### **Architectural Review Board Staff Report**

Meeting Date: June 9th, 2022

**Location:** 722 Long Road Crossing

Description: Long Road Crossing, Lot B-1 (Kia) ASDSP: Amended Site Development

Figure 3: Updated North Elevation

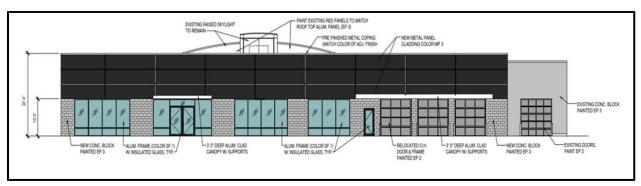
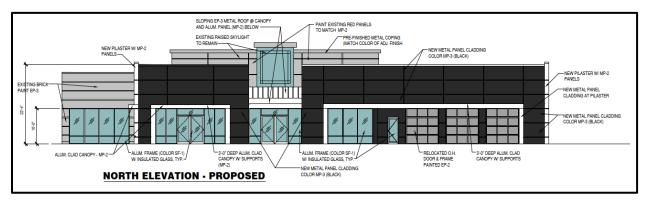
The applicant made changes to the design of the north elevation. These changes include exposing the elevated clearstory element and adding a sloping metal roof canopy and an additional entryway just below. A modular design was also incorporated into the clearstory element.

The previous submittal included an addition that extended the entire length of the existing building. The size of the addition has been revised and now is shorter in length allowing for articulation between the existing and proposed buildings. There have been no changes in the height of the addition since the last submittal.

There are vertical pilasters incorporated in this submittal. They will be a mica platinum color to match the proposed canopies.

Below (Figure 2) is the north elevation that was presented at the May ARB meeting followed by the updated north elevation proposed at the June meeting (Figure 3):

Figure 2: Existing vs Proposed North Elevation

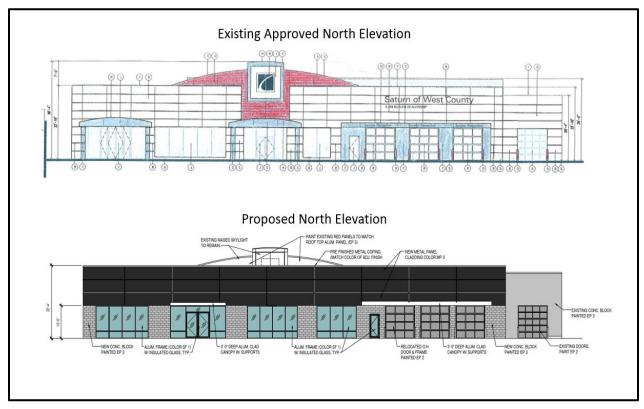
The existing building is primarily painted CMU in an off-white color. The proposed addition will feature new ACM panels and parapets as well as painted CMU in a shade of grey referred to as Sterling Silver. The existing CMU and red panel surrounding the clearstory element will be painted to match the addition. There are currently four (4) overhead doors that face Interstate 64 on the north elevation. Three (3) of these doors will be relocated to accommodate the addition but remaining in the same location along the new northern facade. All four (4) overhead doors will be updated with a Charcoal Slate color. The metal panels wrapping around the top of the building will be black.

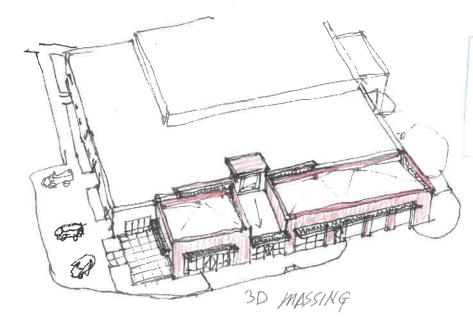
The existing building's front skylight element is being incorporated and updated in keeping with the new look and feel of the ACM panels. The existing front entry canopy structure will be built into the new building. The front elevation's massing has been modified to better highlight the building's functions and provide a clearer identification of the various entries.

AMENDED SITE DEVELOPMENT SECTION PLAN

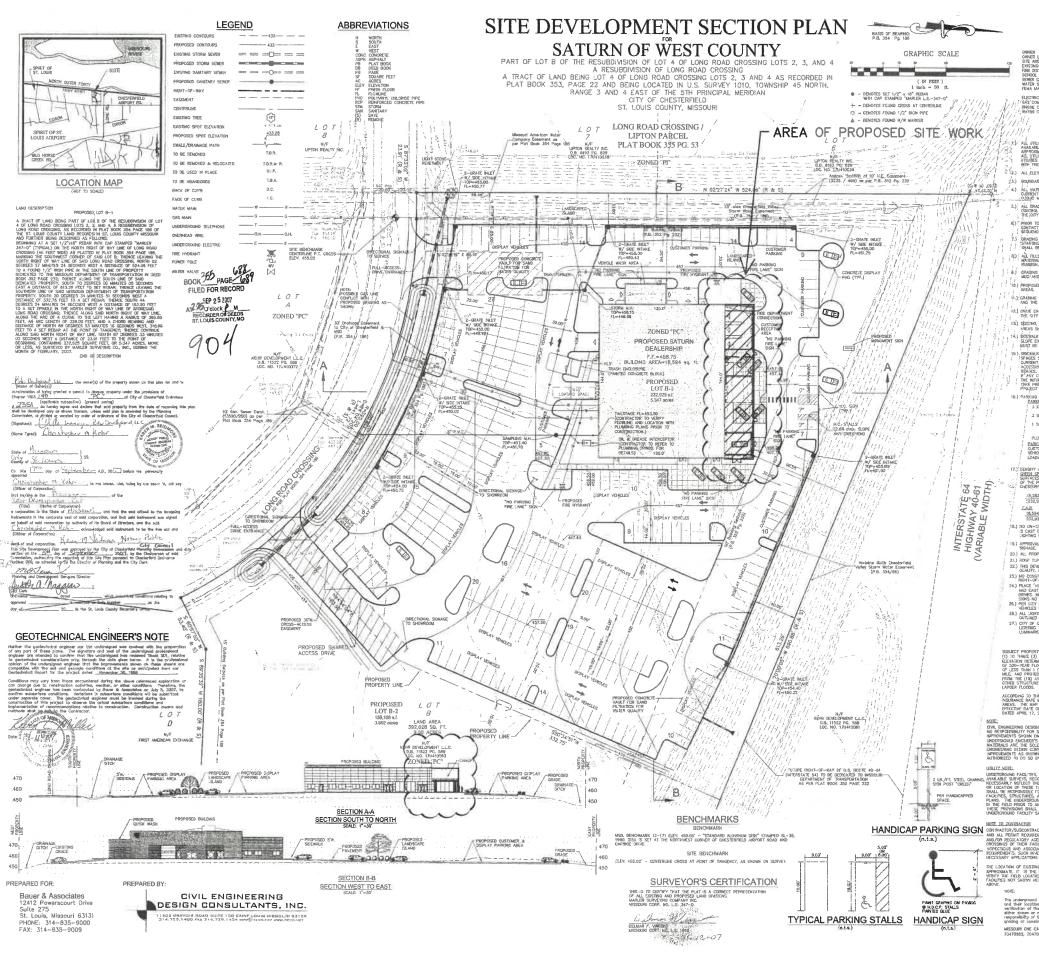
15 27 22 - BUILDING ADDITION REDUCED IN
